West Winder Bypass
CSSTP-0006-00(327), P.I. No. 0006327
Barrow County

Value Engineering Study Report

April 2010

DESCRIPTION: **MODIFY REALIGNMENT OF FRED KILCREASE ROAD TO
 LINE UP WITH A SLIGHT REALIGNMENT OF BILL
 RUTLEDGE ROAD TO THE NORTH**

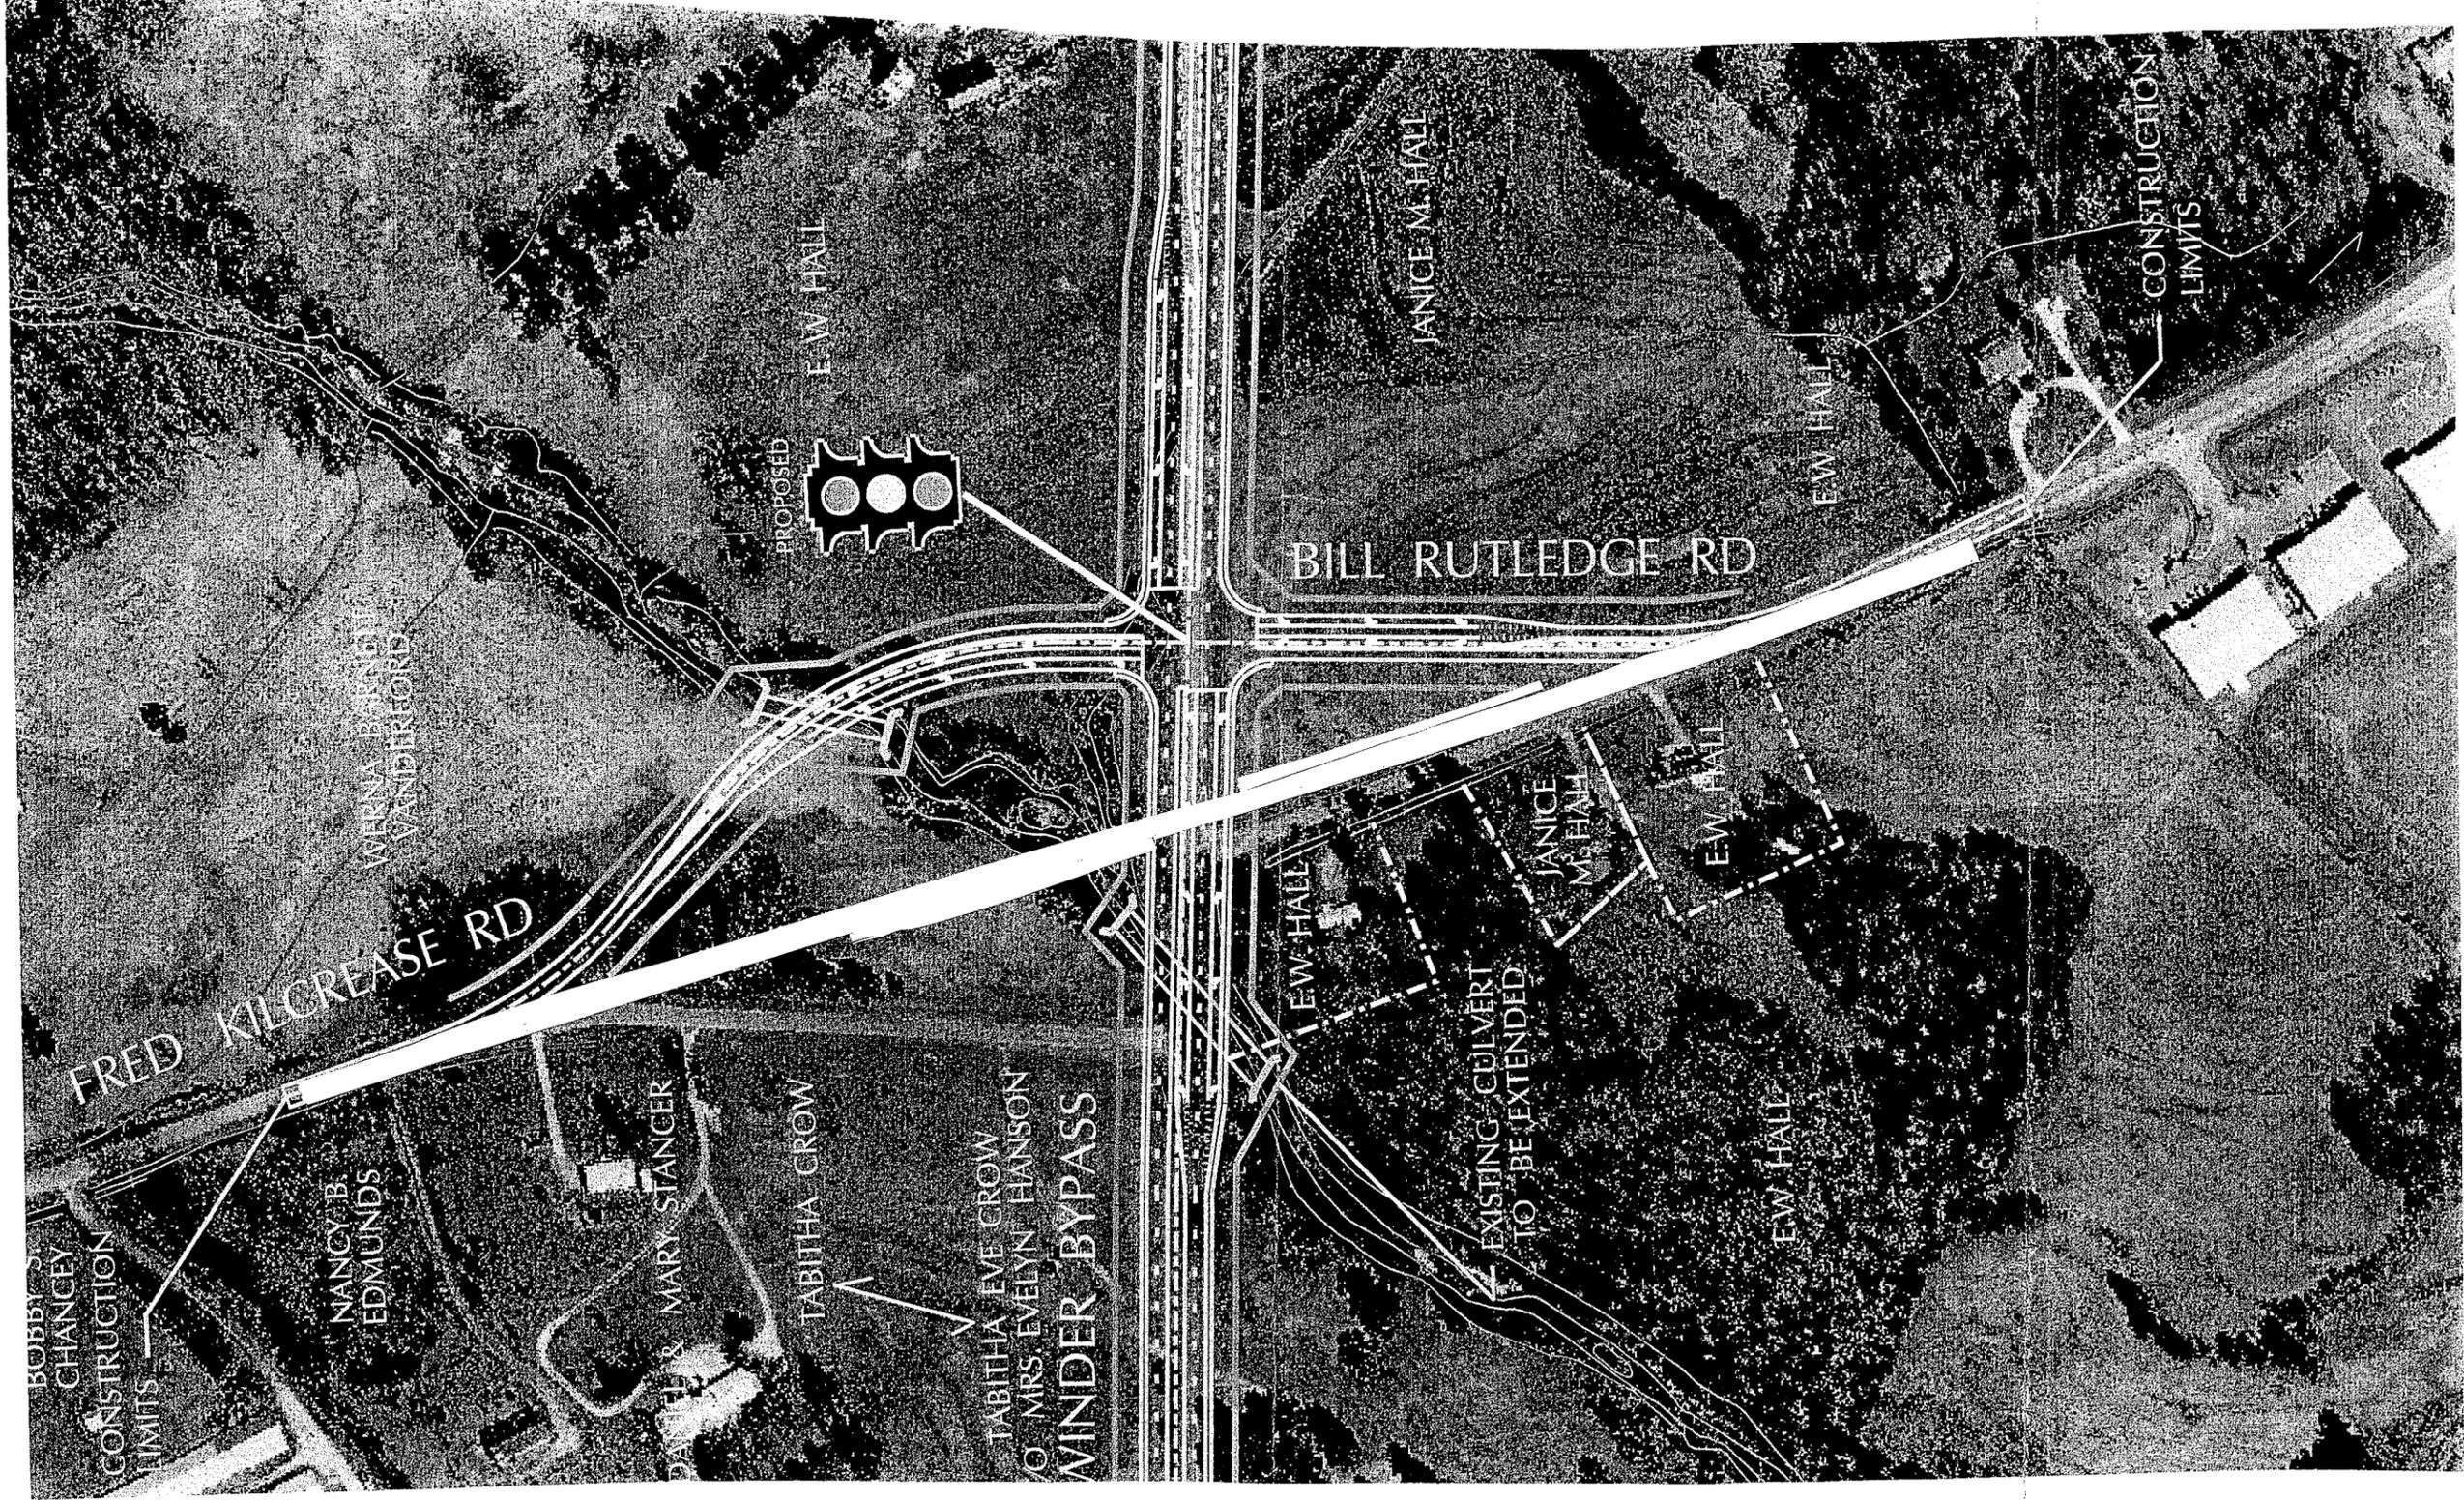
The original design calls for the creation of a new common intersection of Fred Kilcrease Road and Bill Rutledge Road with the West Winder Bypass about 250 feet north of the existing Bill Rutledge Road's intersection with Patrick Mill Road.

Extend Bill Rutledge Road to create a 70 degree intersection with the West Winder Bypass and at the same time slightly realign Fred Kilcrease Road north so that it sits opposite relocated Bill Rutledge Road.

The original design alignment of Bill Rutledge Road will necessitate three permanent easements for current homeowners so that their driveways can be extended from their house to the road. In fact, the house closest to the Winder Bypass will need a 200-ft.-long easement to construct driveway. The other alternative is to sell the land to the homeowners at a price acceptable to them.

However, if Bill Rutledge Road is realigned as proposed in this alternative, the property lines for the houses will remain on the existing right-of-way line and just a short distance from the edge of the new roadway. On the west side of the West Winder Bypass, much less of the Werna Barnett Vanderford property is impacted to construct the relocated Free Kilcrease Road and expanded box culvert.
